(Catawba Nuclear Station,
Units 1 and 2))

Docket Nos. 50-413
50-414

APPLICANTS' RESPONSES TO CESG'S DISCOVERY AND DOCUMENT
PRODUCTION REQUESTS TO NRC STAFF AND TO APPLICANT RE CESG
CONTENTION 18 AND RE DES CONTENTION 17

AZIMUTHAL DISTRIBUTION OF MAXIMUM FAST NEUTRON FLUX ($E > 1.0$ MeV) AT THE PRESSURE VESSEL INNER RADIUS - CATAWBA UNITS 1 + 2

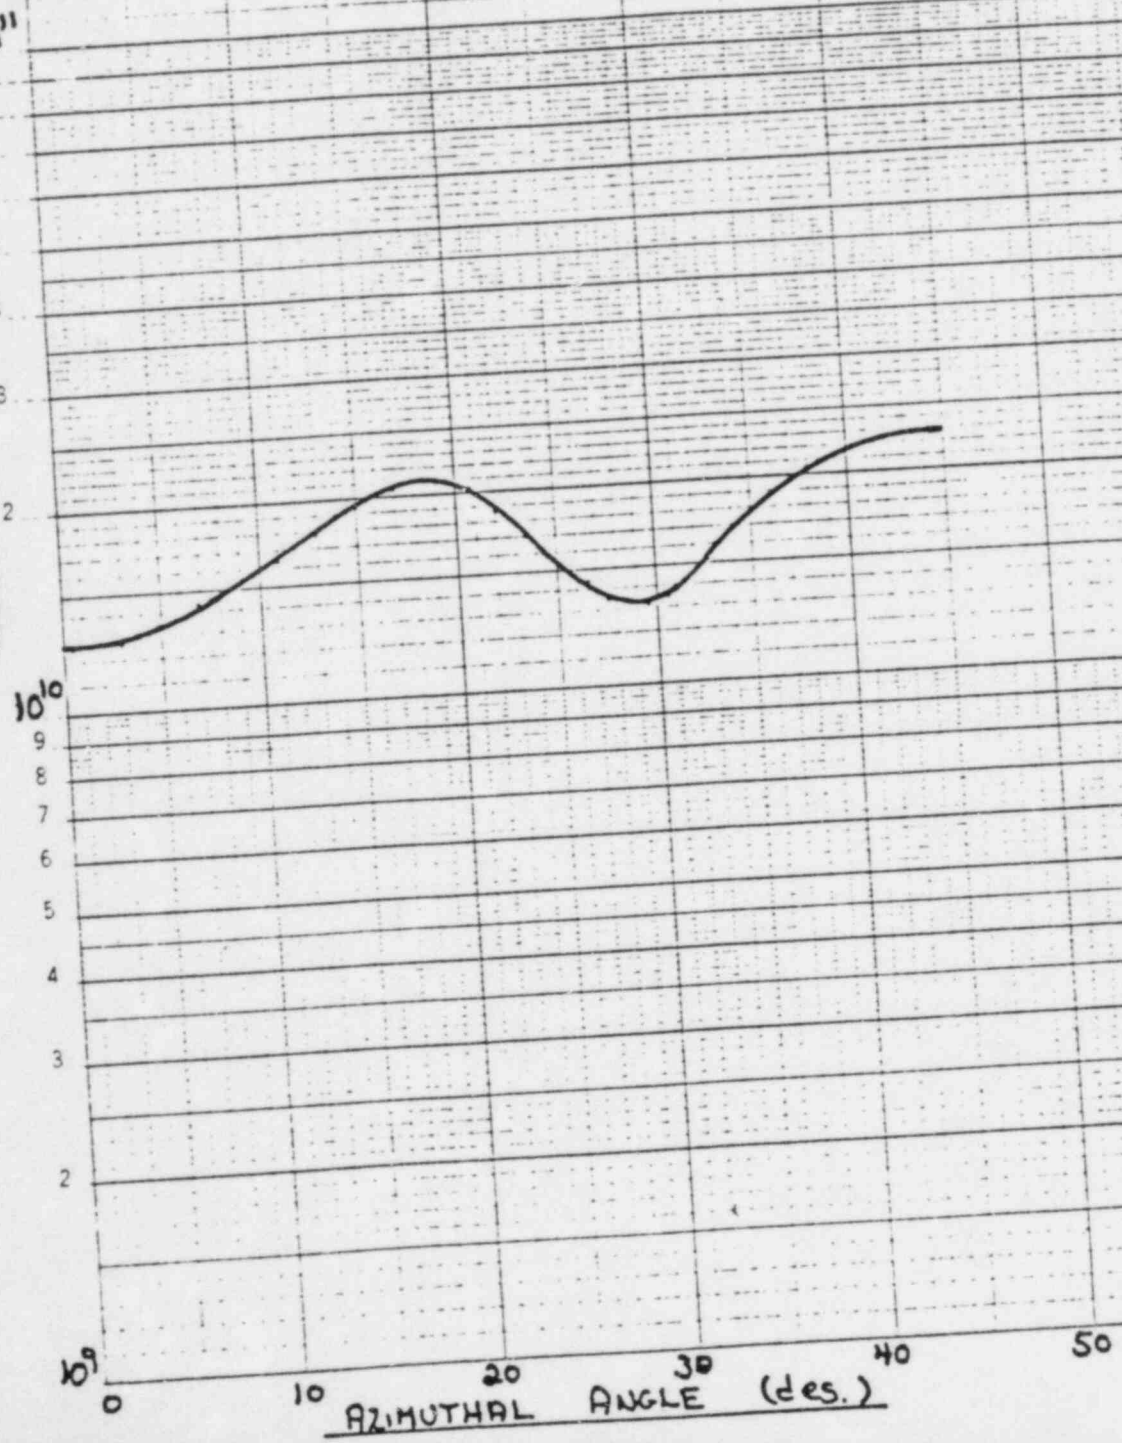
6. Pursuant to 4., foregoing, For the core to be employed at Catawba, diagram relative neutron fluences around the beltline.

See Attachment A and FSAR Table 5.3.1-5. (RWO) (RHF)
